HISTORIC AND DESIGN REVIEW COMMISSION

HDRC CASE NO: 2017-397
ADDRESS: 415 WILLOW DR
LEGAL DESCRIPTION: NCB 1653 BLK A LOT N 55 FT OF 17 & 18
ZONING: R-5
CITY COUNCIL DIST.: 2
DISTRICT: Dignowity Hill Historic District
APPLICANT: Eduardo Villalon
OWNER: Eduardo Villalon
TYPE OF WORK: Construction of a two story, single family residential structure
REQUEST:

The applicant is requesting conceptual approval to construct a one and a half story single family home.

FRONT ELEVATION

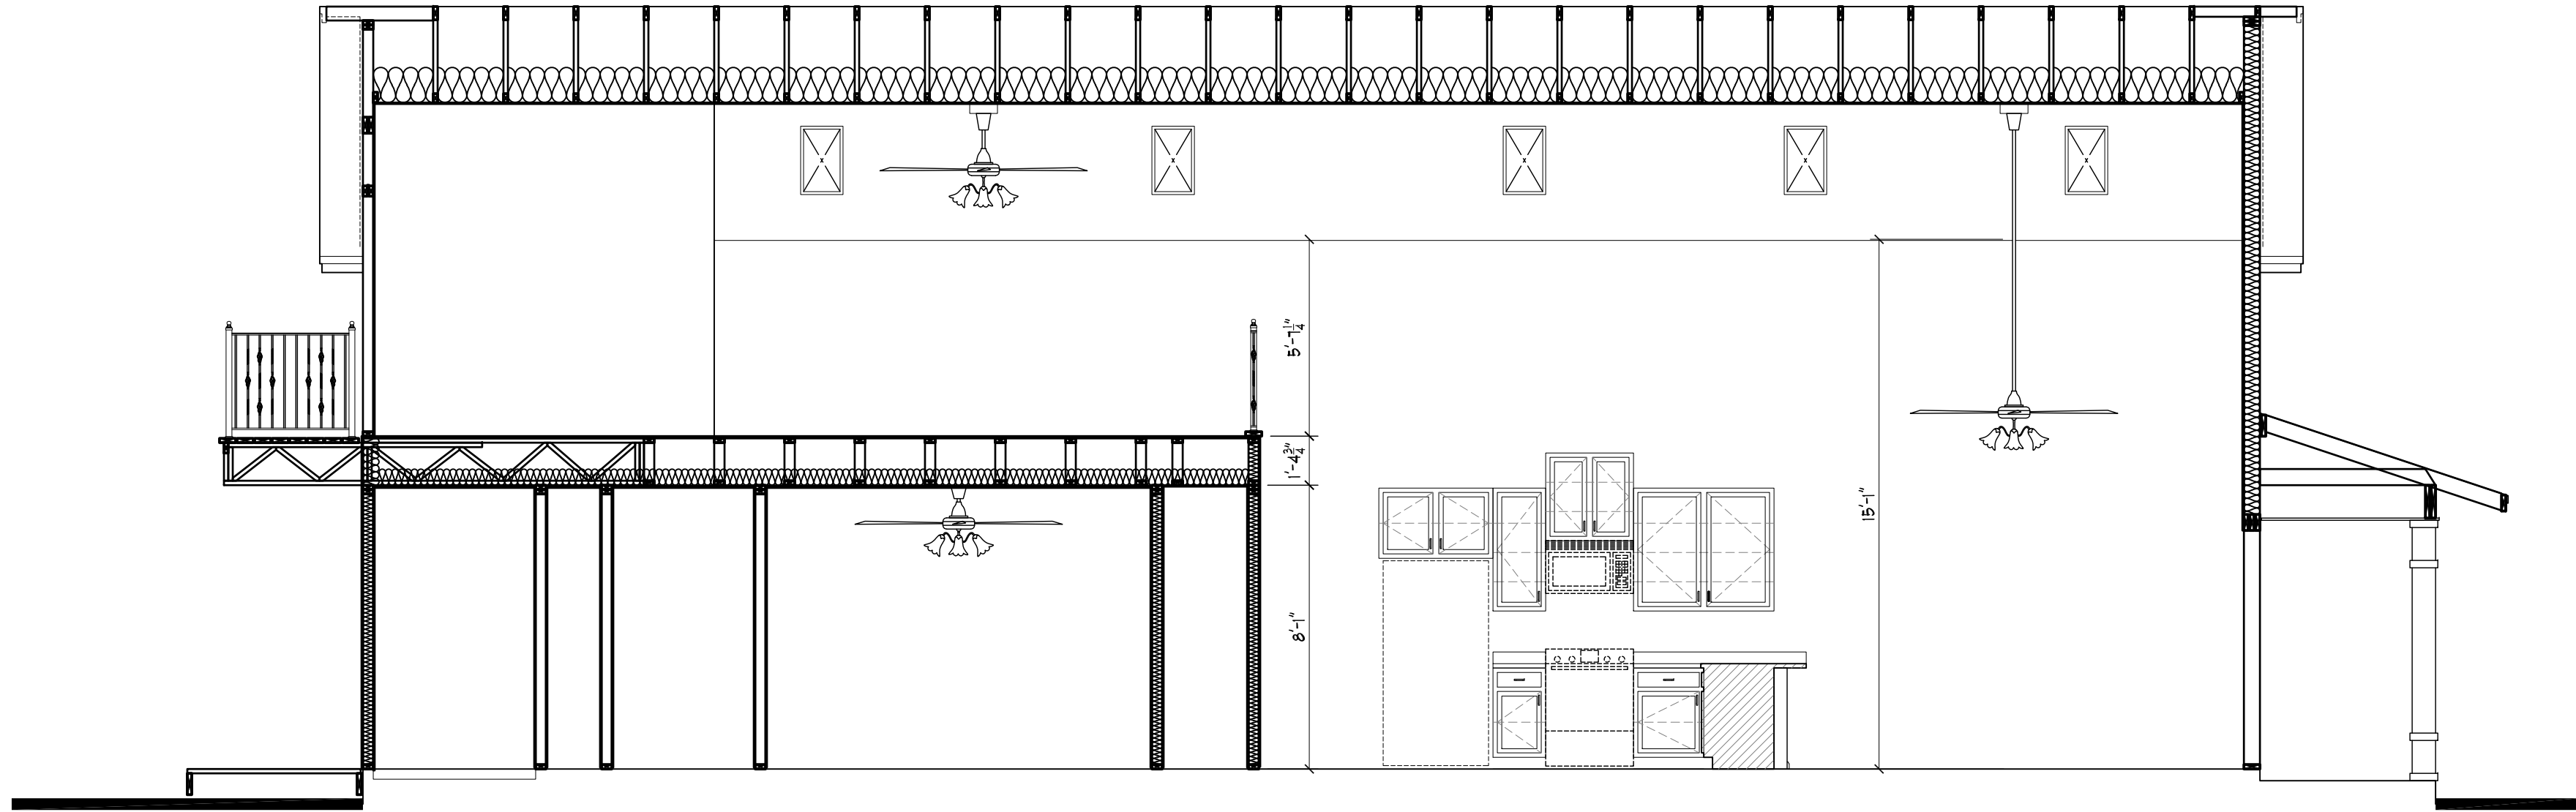
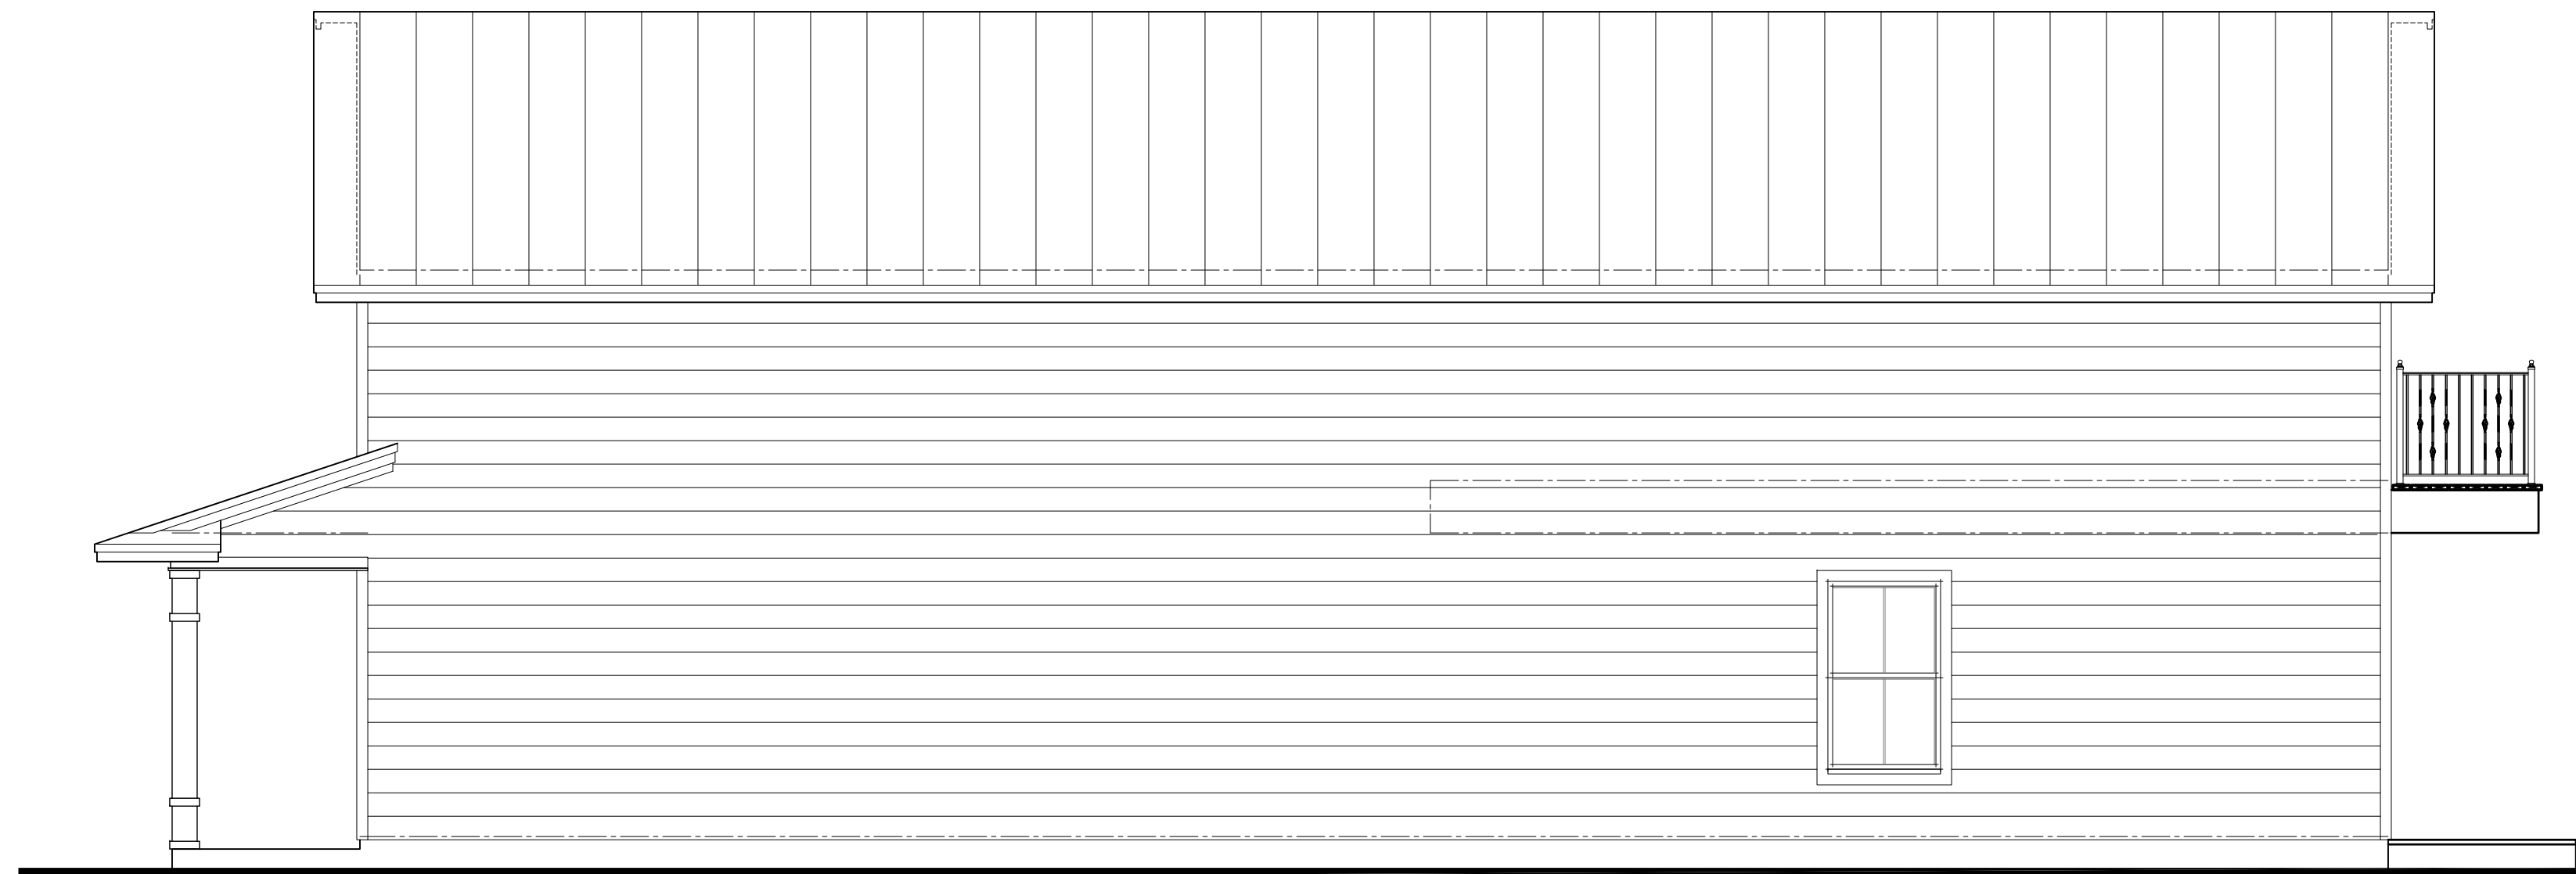
- e. **SCALE & MASS** – Per the Guidelines for New Construction 2.A.i., a height and massing similar to historic structures in the vicinity of the proposed new construction should be used. In residential districts, the height and scale of new construction should not greatly exceed the historic precedent. Each of the three historic structures that are oriented toward Willow as well as the majority in the immediate vicinity feature heights of one story. The applicant has noted a top plate height of 15' – 1" with an approximate seven feet of height from the top plate to the ridge line for an overall height of approximately twenty-two (22) feet. Staff does not find the proposed height to be consistent with the Guidelines. Staff finds that the overall height should be reduced through the shortening of the second story or the lowering of the top plate height to produce an overall height that is comparable with the heights of neighboring, historic structures.

- g. **ROOF FORM** – The applicant has proposed both a front and side gabled roof. There are historic examples of both front and side gabled roofs throughout the Dignowity Hill Historic District. On both the front and side gabled roofs, the applicant has incorporated gable returns, which are not elements found on historic structures. Staff finds that the proposed gable returns should be eliminated.

- h. **WINDOW & DOOR OPENINGS** – Per the Guidelines for New Construction 2.C.i., window and door openings with similar proportions of wall to window space as typical with nearby historic facades should be incorporated into new construction. The applicant has proposed window and door openings that are generally consistent with those found on historic structures in regards to location and size with the exception of the right elevation, which features only one window opening. Staff finds that the applicant should install additional window fenestration on the right elevation as well as on the second level of the left elevation.

- i. That the applicant provide information noting the setbacks of adjacent historic structures and that the proposed new construction matches.
- ii. That the applicant reduce the proposed height through the shortening of the second story or the lowering of the top plate height to produce an overall height that is comparable with the heights of neighboring, historic structures.

- iii. That the applicant incorporate a sloping soffit design and eliminate the gable returns on the proposed gabled roofs as noted in finding g.
- iv. That the applicant introduce additional window fenestration to the right and left elevations as noted in finding h.
